Access Compliance Report

Public Rights-of-Way

(Curb Ramps)

Intersection ID: 20241	Main Street: ANN_MARIE_DR	Cross Street: NATIONS_FORD_RD	Location: SW
ADA ID: 75FD48F10755	Ramp Type: BlendTrans2	Initial Pass/Fail: Fail	Overall Compliance: No
Severity Score: 10			
Codes/Mitigation Info/Possible Solution		Field Measurements/Component Compliance

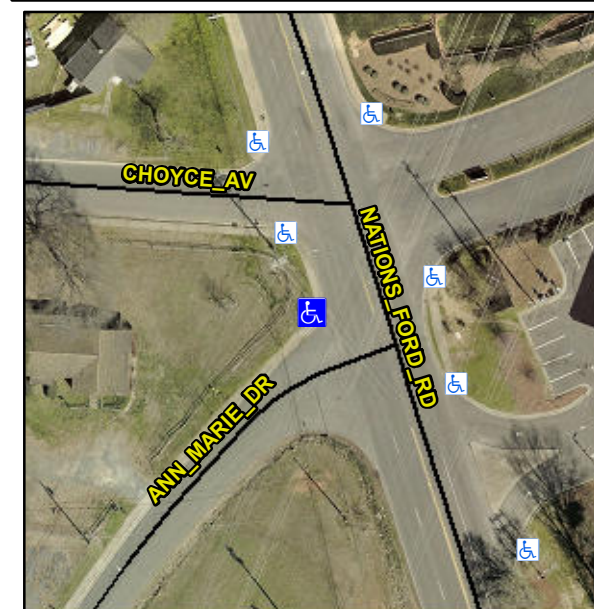
Not Found, R304.5.1, R304.5.3

Compliance	Description	Data	Compliance	Description	Data
N/A	Ramp Length (in)	48.0	Yes	BlendTrans Slope (%)	2.6
No	Ramp Width (in)	38.0	No	BlendTrans XSlope (%)	2.5
N/A	Flare Type LT	N/A	N/A	Flare Type RT	N/A
N/A	Flare Slope LT (%)	N/A	N/A	Flare Slope RT (%)	N/A
N/A	Flare Traversable LT?	N/A	N/A	Flare Traversable RT?	N/A
N/A	Landing Length (in)	N/A	N/A	DWS Provided?	N/A
N/A	Landing Width (in)	N/A	N/A	DWS Contrast?	N/A
N/A	Landing Slope (%)	N/A	N/A	DWS Length (in)	N/A
N/A	Landing X Slope (%)	N/A	N/A	DWS Full Width?	N/A
N/A	Landing Curb? (Y/N)	N/A	N/A	DWS Offset (in)	N/A
N/A	Shared Landing?	N/A			
N/A	Gutter Ponding?	N/A	N/A	Gutter Slope (%)	N/A
N/A	Gutter Lip Ht (in)	N/A	N/A	Gutter X Slope (%)	N/A
N/A	Painted X Walk1?	No	N/A	Painted X Walk2?	No
	X Walk 1 Direction	To S		X Walk 2 Direction	To E
	X Walk 1 Width (in)	N/A		X Walk 2 Width (in)	N/A
	X Walk 1 Slope (%)	4.5		X Walk 2 Slope (%)	2.0
	X Walk 1 X Slope (%)	1.1		X Walk 2 X Slope (%)	3.9

N/A	Ramp inside XWalk1?	N/A	N/A	Ramp inside XWalk2?	N/A
	Road Slope (%)	1.2		Clear Space?	N/A
	Road X Slope (%)	6.9	N/A	Clear Space to XWalk (in)	N/A
N/A	Any Obstructions?	N/A	N/A	Storm Grate/Utility Hazard?	N/A
	Obstruction Type			Storm Grate/Utility Type	
		N/A			N/A
			Yes	Surface Condition? (G/P)	Good
			No	Curb Slope (%)	5.5

Remove & Replace Curb Ramp With Two New Directional Ramps or Equivalent.
